MIL-M-28787/81A(SH)
AMENDMENT 2
30 March 1992
SUPERSEDING
AMENDMENT 1
14 November 1983

MILITARY SPECIFICATION

MODULES, STANDARD ELECTRONIC

MULTIPLEXER, DIGITAL, KEY CODE KHL

FIGURE 7 V_{OUT} (low-loaded) test circuit for table IV

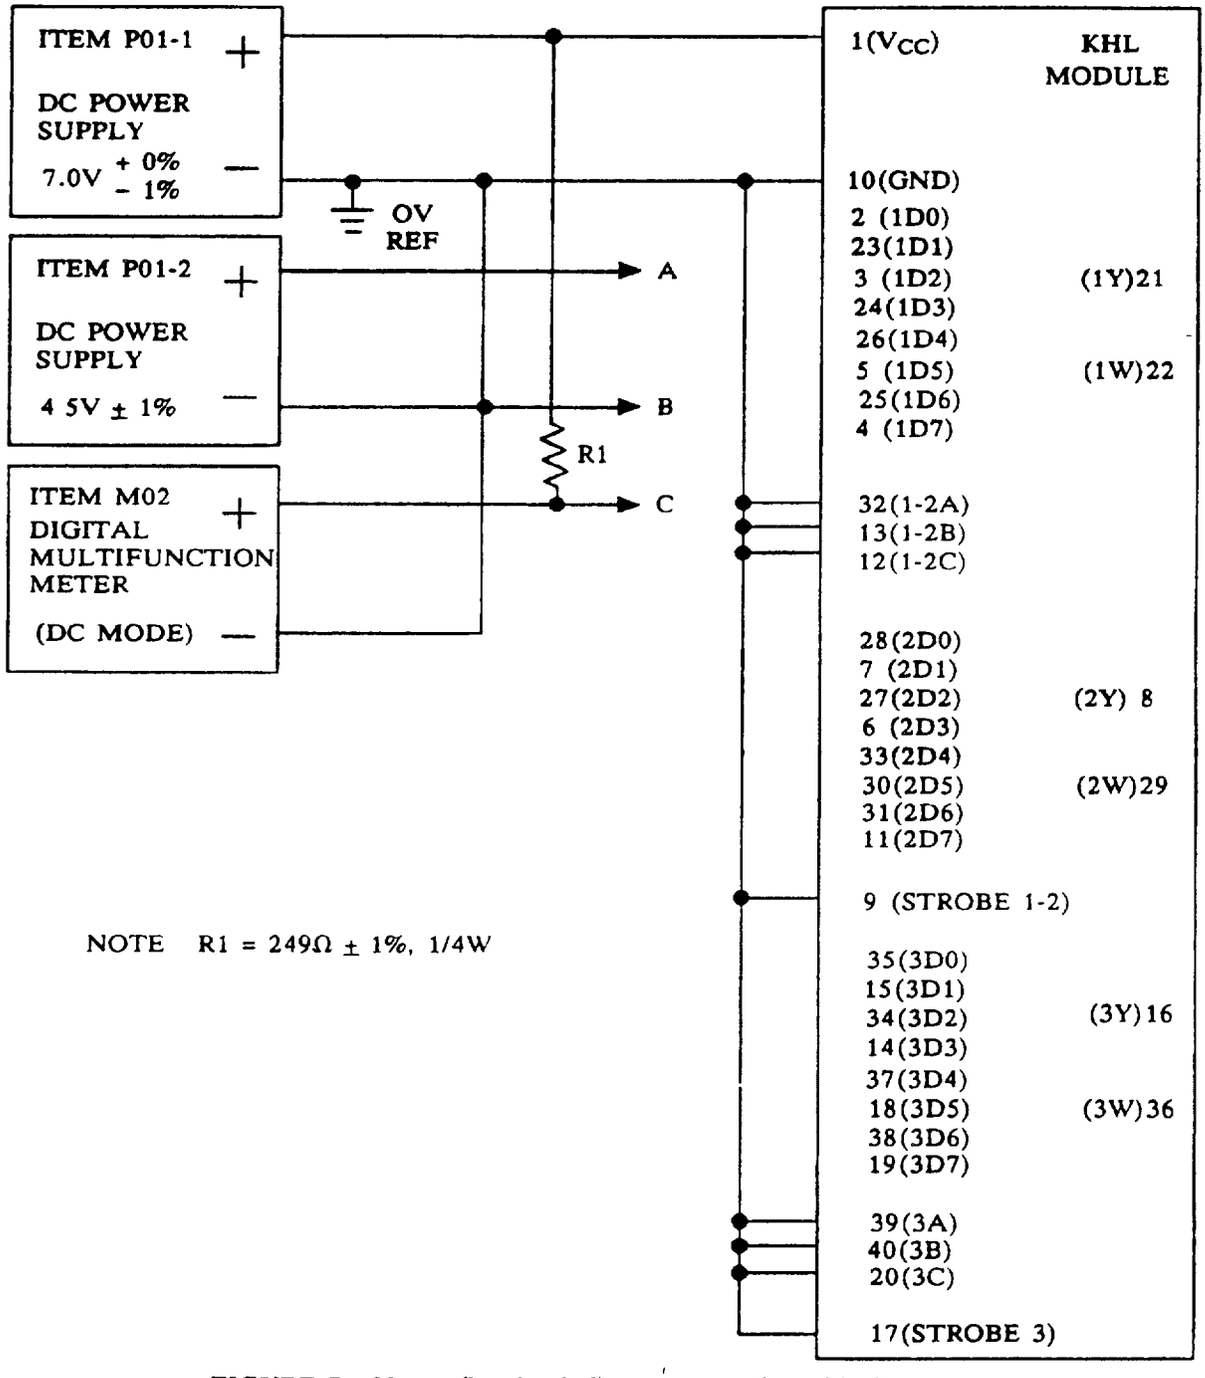
FIGURE 7 Delete and substitute new figure 7 as printed on page 4 of this amendment

NOTE R1 = 249Ω ± 1%, 1/4W

FIGURE 11. Functional test circuit for table VIII

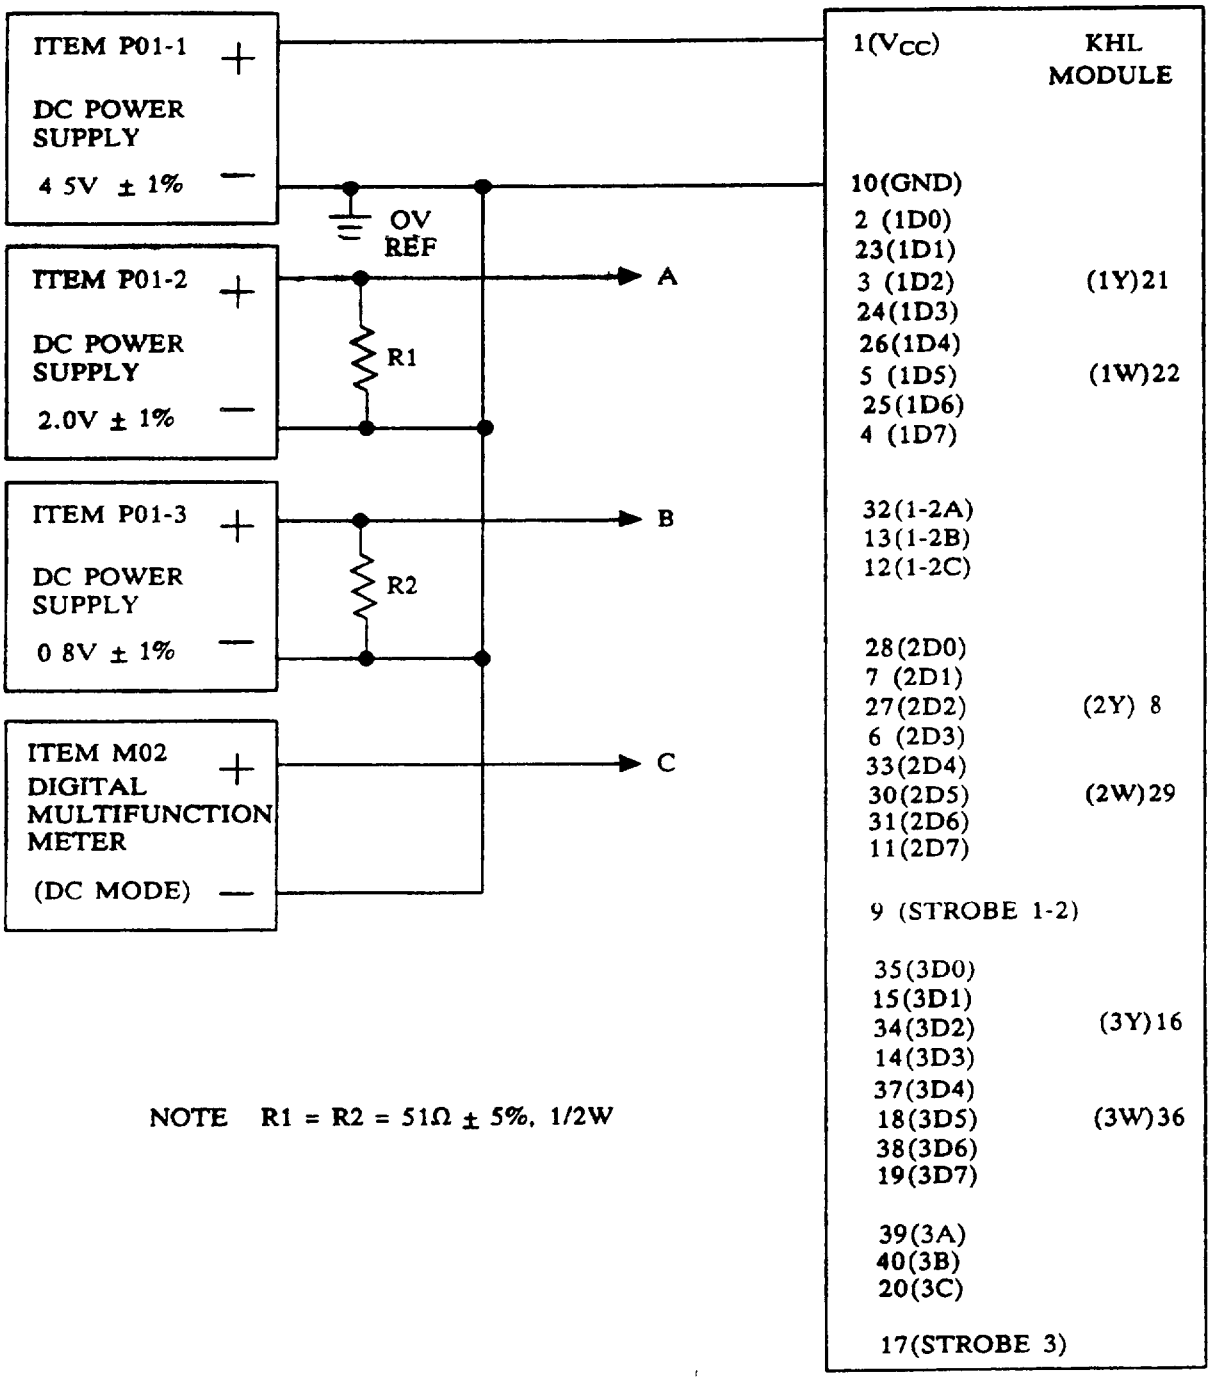
FIGURE 11 Delete and substitute new figure 11 as printed on page 5 of this amendment

NOTE R1 = R2 = 51Ω ± 5%, 1/2W

FIGURE 12 Input clamp diode voltage test circuit for table IX

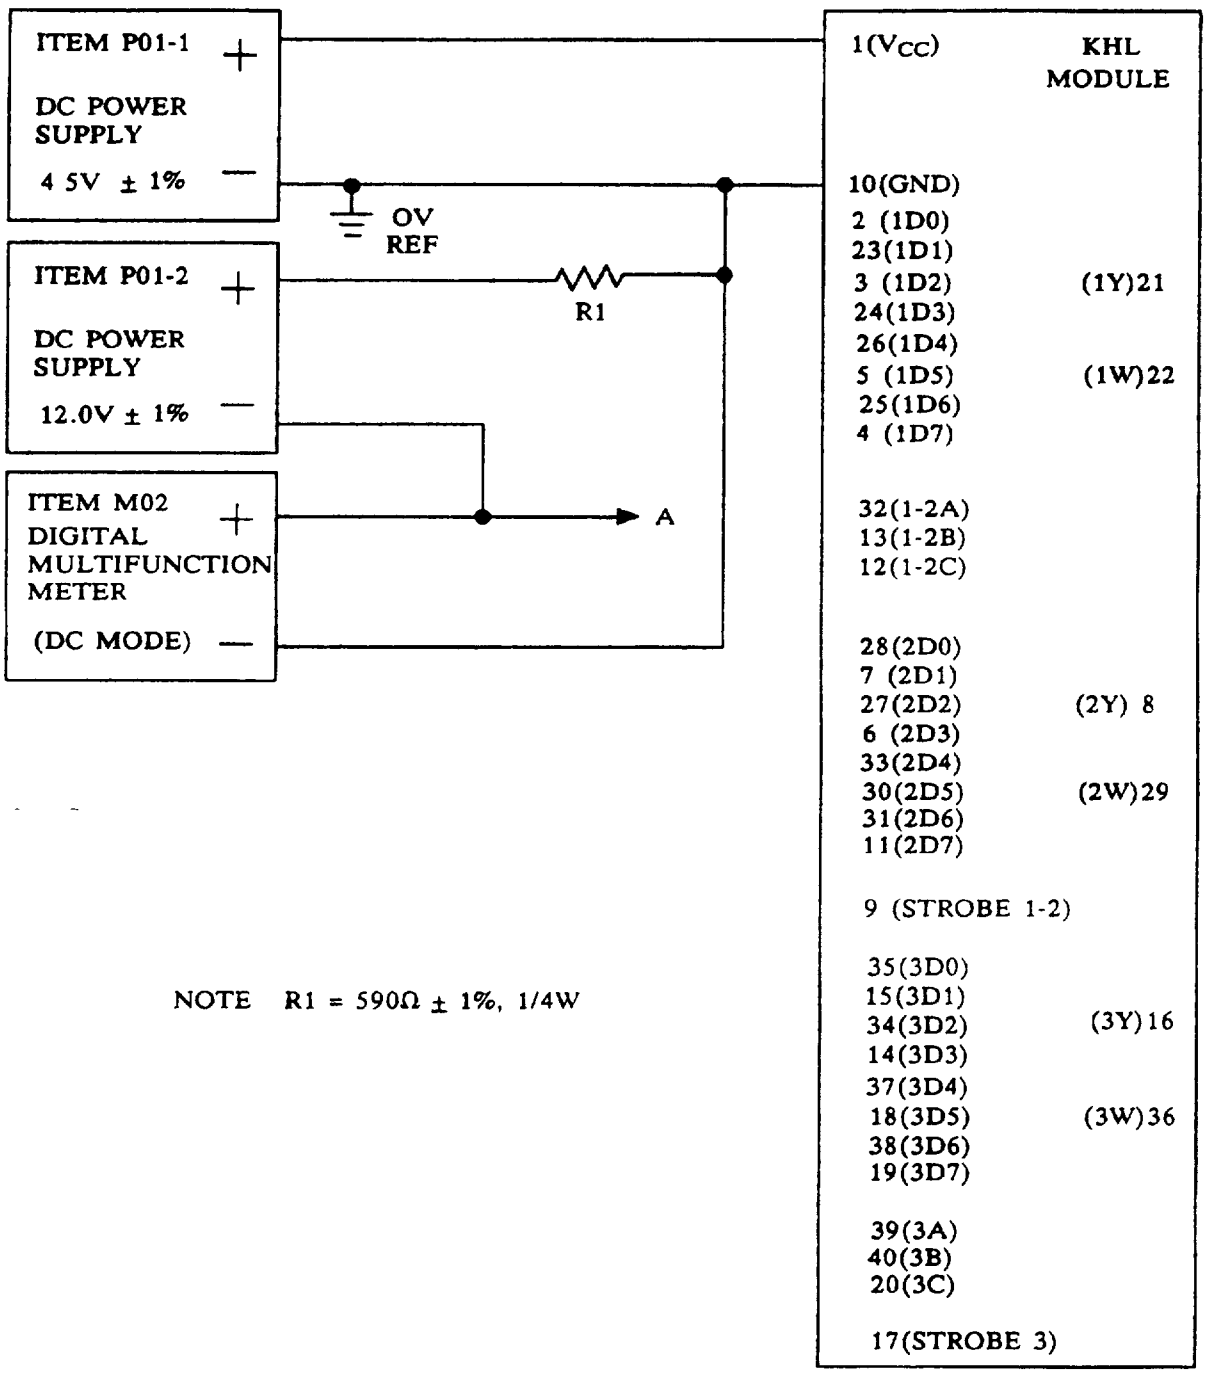
FIGURE 12. Delete and substitute new figure 12 as printed on page 6 of this amendment

NOTE R1 = 590Ω ± 1%, 1/4W

FIGURE 13. Static output voltage (low-level and high-level) test circuit for tables X and XI.

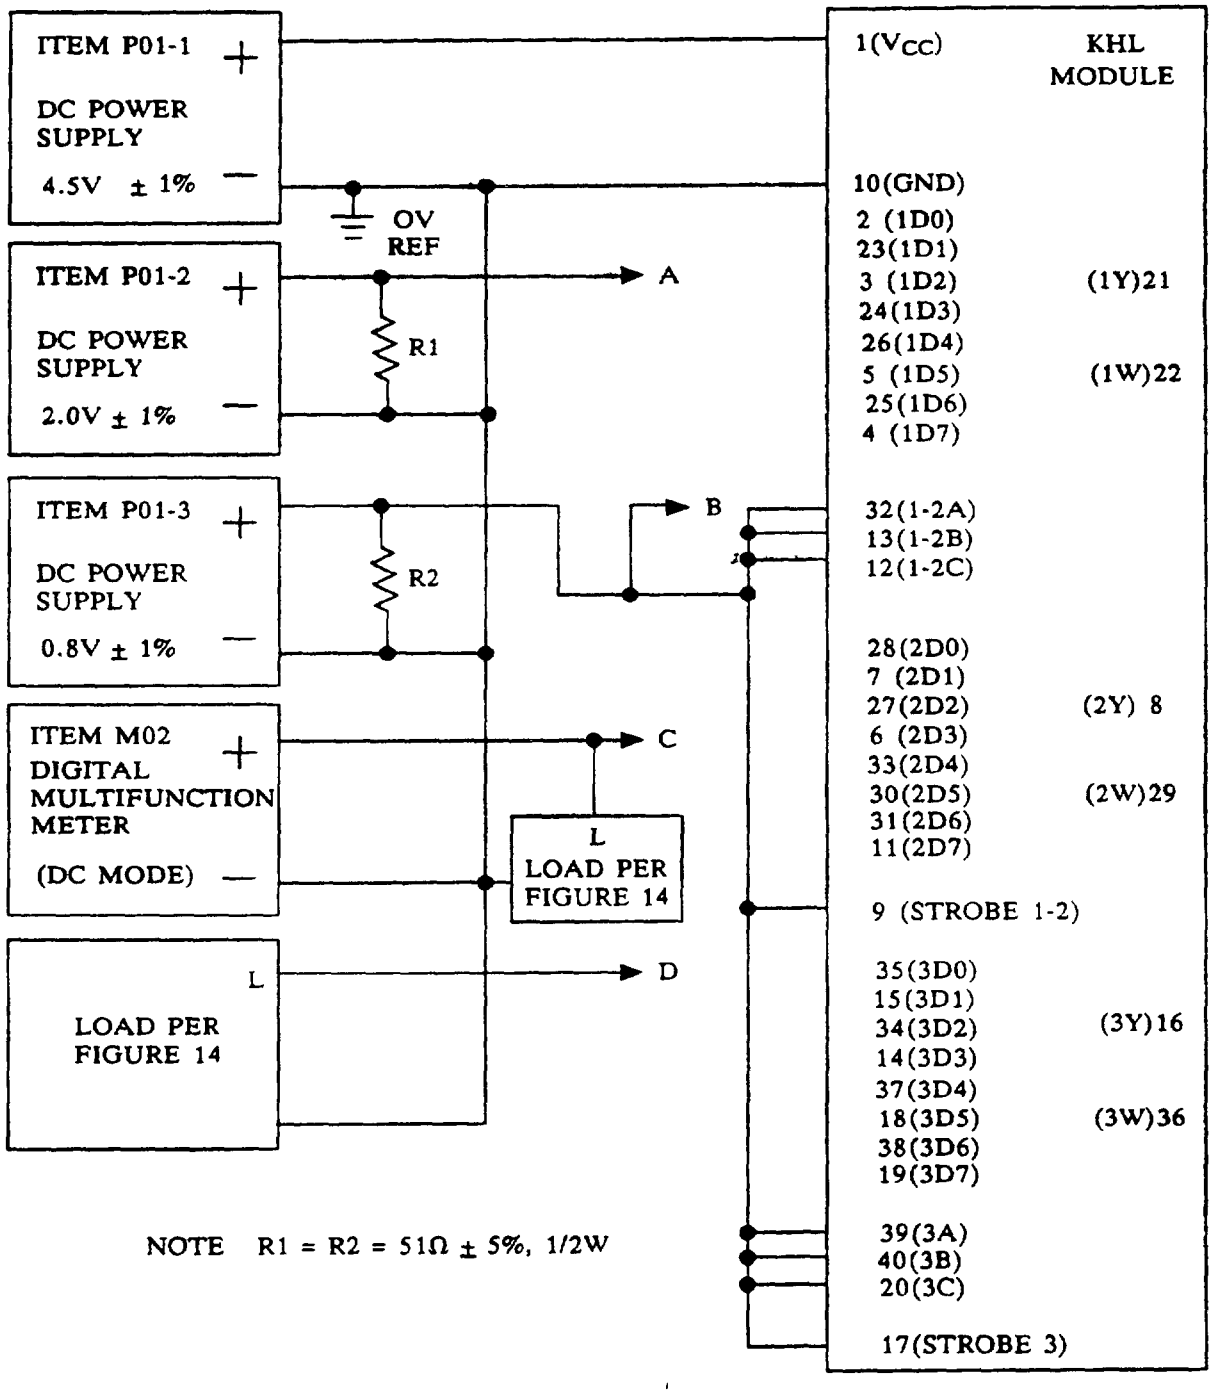
FIGURE 13 Delete and substitute new figure 13 as printed on page 7 of this amendment.
